UNITED STATES PATENT AND TRADEMARK OFFICE

APPLICATION NO.	FILING DATE	FIRST NAMED INVENTOR	ATTORNEY DOCKET NO.	CONFIRMATION NO.
10/664,498	09/19/2003	Gary Karlin Michelson	102.0003-09000	4672
22882	7590	11/16/2005	EXAMINER	
MARTIN & FERRARO, LLP 1557 LAKE O'PINES STREET, NE HARTVILLE, OH 44632			HO, UYEN T	
			ART UNIT	PAPER NUMBER
			3731

Office Action Summary

DETAILED ACTION

FIG. 14B

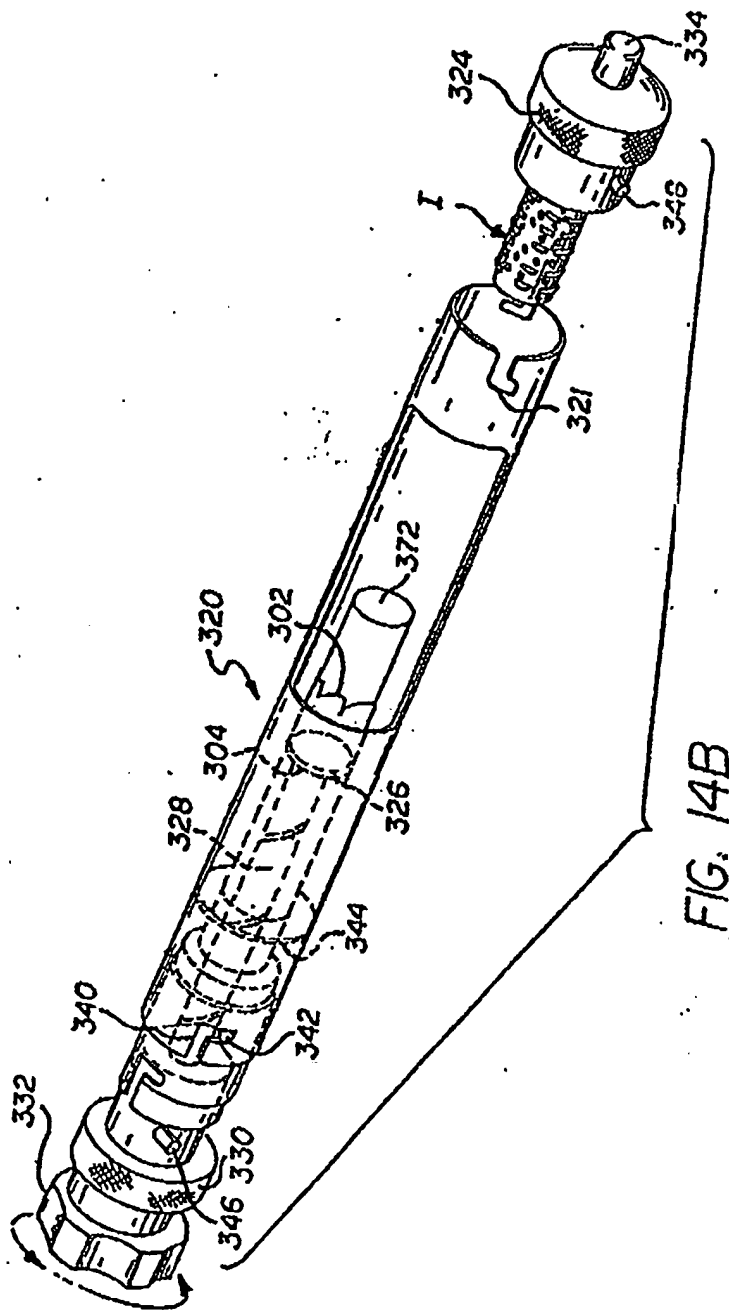
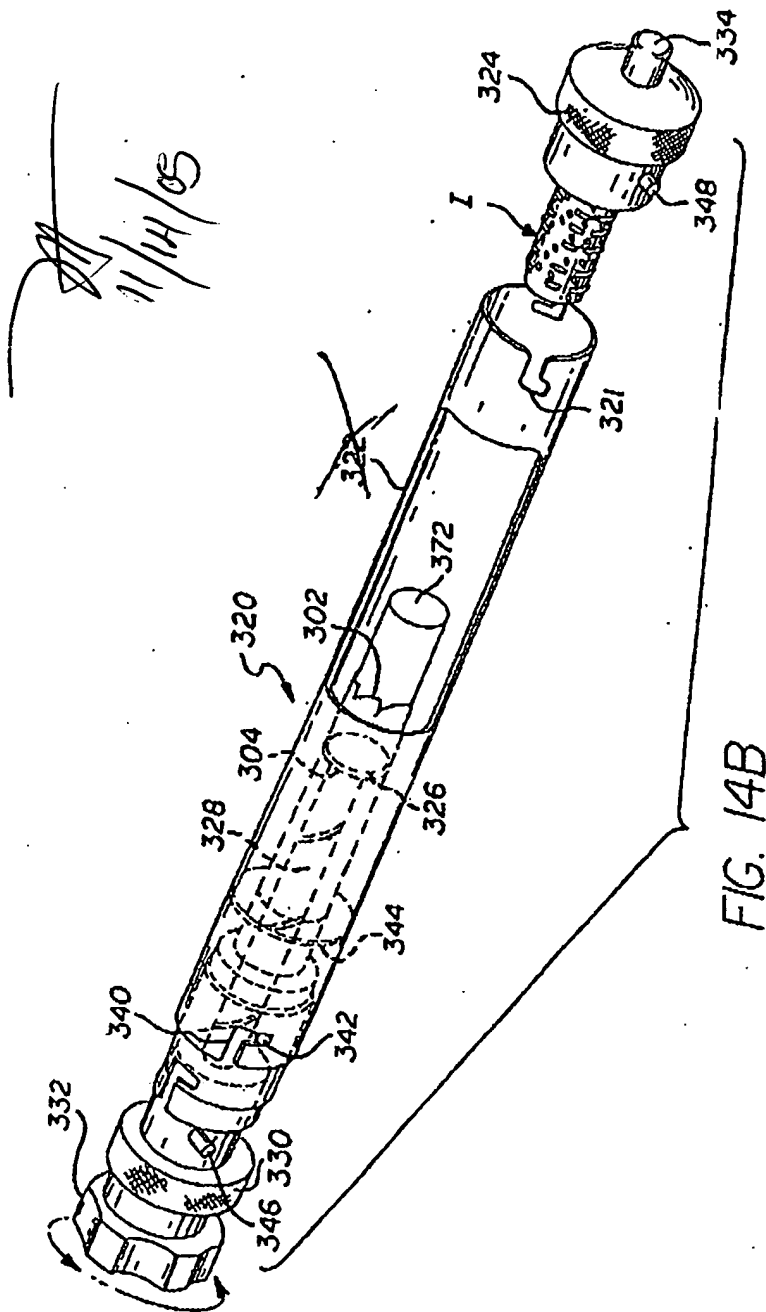
1. Applicant's arguments filed 08/24/05 have been fully considered but they are not persuasive. Regarding to the drawings, applicant argues that the access port intersecting the cavity to receive osteogenic material is identified by the reference number 340 Fig. 14B. Examiner disagrees. Reference 340 is identified as an opening for receiving osteogenic material however it does not intersect the cavity but instead, the opening 340 is an end portion of the cavity. Merriam-Webster's Collegiate Dictionary, page 612, 10th ed. (1999), "intersecting" is "to meet and cross at a point". According to the figures as shown in the Merriam-Webster's Collegiate Dictionary, page 612, 10th ed. (1999), two elements with two different planes meet at point "a." The opening 340 shares the same common axis, the same plane with the cavity and is a part of the cavity therefore it cannot intersect the cavity.

4. The drawings are objected to under 37 CFR 1.83(a). The drawings must show every feature of the invention specified in the claims. Therefore, an access port intersecting the cavity to receive osteogenic material must be shown or the feature(s) canceled from the claim(s). No new matter should be entered.

Corrected drawing sheets in compliance with 37 CFR 1.121(d) are required in reply to the Office action to avoid abandonment of the application. Any amended replacement drawing sheet should include all of the figures appearing on the immediate prior version of the sheet, even if only one figure is being amended. The figure or figure number of an amended drawing should not be labeled as "amended." If a drawing figure is to be canceled, the appropriate figure must be removed from the replacement sheet, and where necessary, the remaining figures must be renumbered and appropriate changes made to the brief description of the several views of the drawings for consistency. Additional replacement sheets may be necessary to show the renumbering of the remaining figures. Each drawing sheet submitted after the filing date of an application must be labeled in the top margin as either "Replacement Sheet" or "New Sheet" pursuant to 37 CFR 1.121(d). If the changes are not accepted by the examiner, the applicant will be notified and informed of any required corrective action in the next Office action. The objection to the drawings will not be held in abeyance.
